UNITED STATES PATENT AND TRADEMARK OFFICE

APPLICATION NO.	FILING DATE	FIRST NAMED INVENTOR	ATTORNEY DOCKET NO.	CONFIRMATION NO.
10/730,877	12/09/2003	Darren A. Janzig	1023-335US01	4792
28863	7590	06/05/2006	EXAMINER	
SHUMAKER & SIEFFERT, P. A. 8425 SEASONS PARKWAY SUITE 105 ST. PAUL, MN 55125			ALTER, ALYSSA M	
			ART UNIT	PAPER NUMBER
			3762

Office Action Summary

DETAILED ACTION

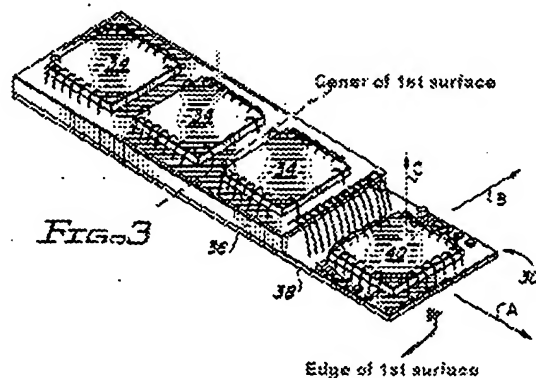
As to claim 9, the height of the integrated circuits increase from an edge towards the center. A replication of figure 3 is included and displays the integrated

circuit 40 on the edge of the first surface is at a smaller height than the integrated circuit 34 towards the center of the first surface.

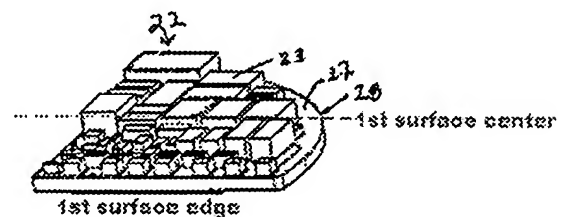
As to claim 9, the height of the integrated circuits increase from an edge towards the center. A replication of a portion of figure 7 is included and displays the integrated circuit on the edge of the first surface is at a smaller height than the integrated circuit towards the center of the first surface.
